Errata Sheet

Product Family: C-more Micro-Graphic Touch Panels

Manual Number EA1-TCL-M

Revision and Date 2nd Ed. Rev. A, 07 / 2013

Page 6-29:

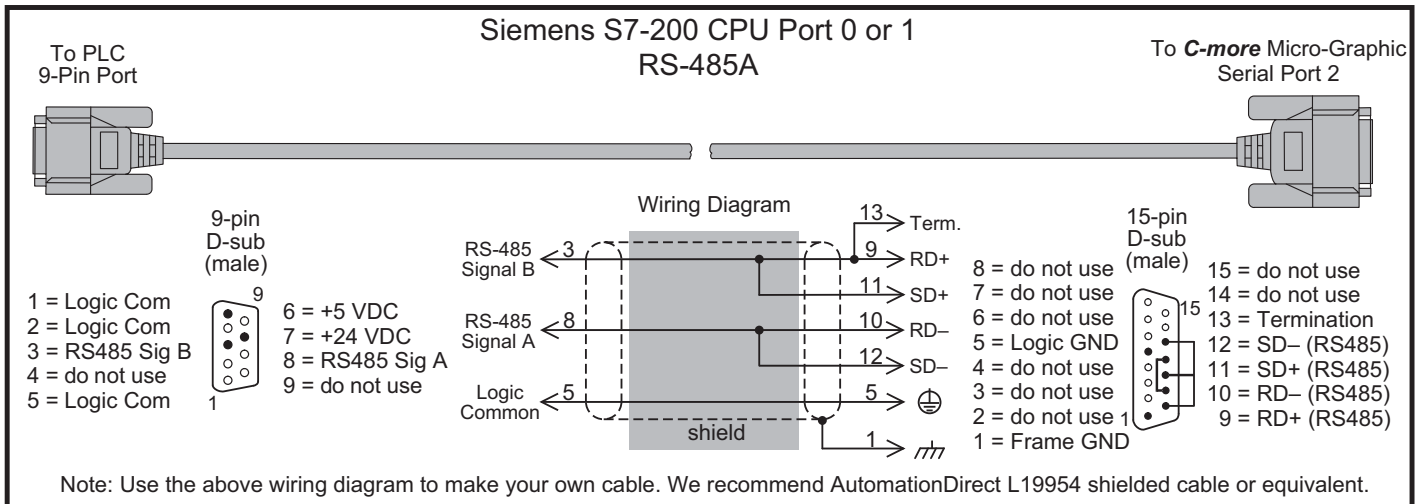
Siemens S7-200 CPU - RS-485 wiring diagram has been corrected.

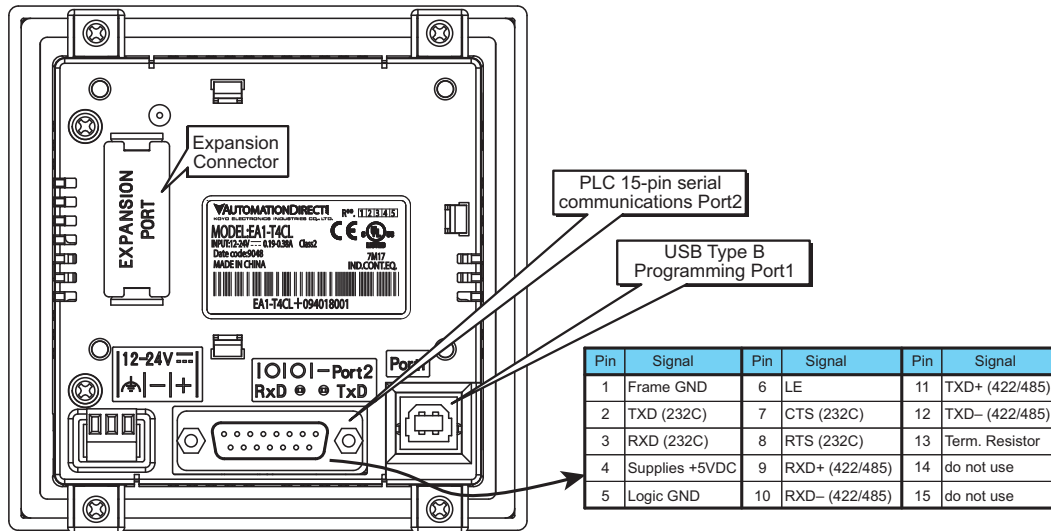
Revised all instances of communication wiring diagrams as shown below.

Port 1 - Pin 5 - receives 5VDC

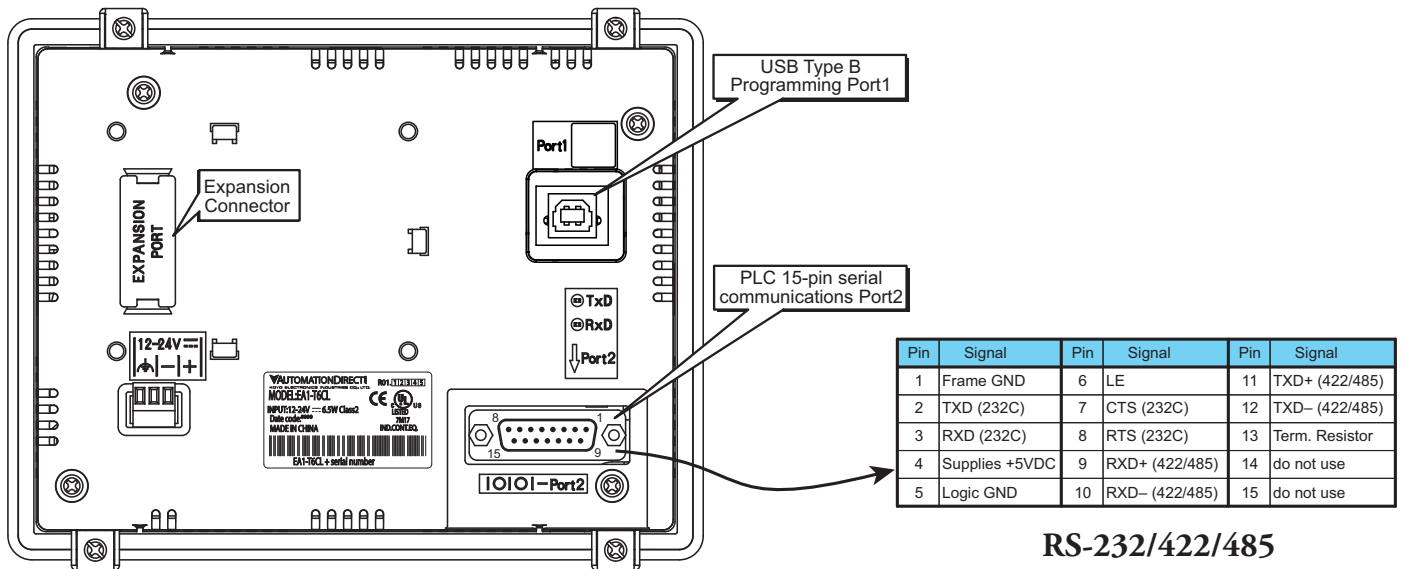
Port 2 - Pin 4 - supplies +5VDC
